Our ref: 14246
Date: 28 April 2026

Application ref: DM/25/3129
Location: Land At Borde Hill Lane Haywards Heath West Sussex
Proposal/Description: Outline planning application for the erection of up to 117 dwellings, together with the provision of landscaping, open space, and associated development works, with access from Balcombe Road. All matters reserved except for access. (Amended plans and supporting statements received 15th April reducing the number of proposed dwellings to up to 117 and reducing the size of the proposed roundabout).

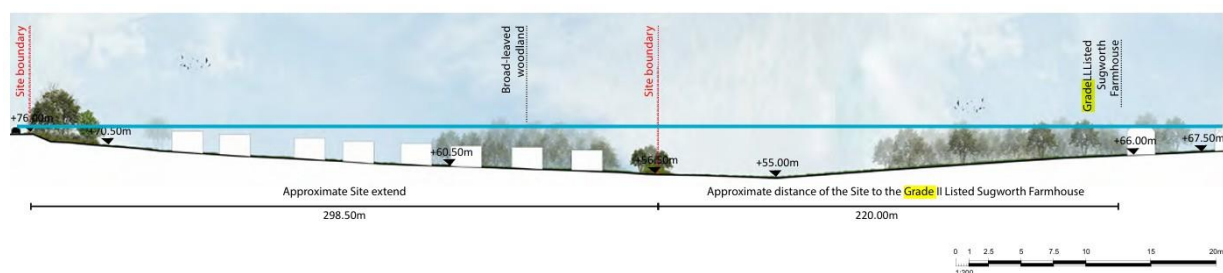
- 1.6. Cross Sections have been provided within Figure 1.3-1.5 of the Landscape Design Statement. Based on the below drawn line over the cross section, we remain unconvinced that the Sugworth Farmhouse will be wholly visible above the rooflines of proposed dwellings. The upper parts of Sugworth Farmhouse may be visible from the roundabout, however based on available information, we judge that most of the building and its setting will likely be screened from view.
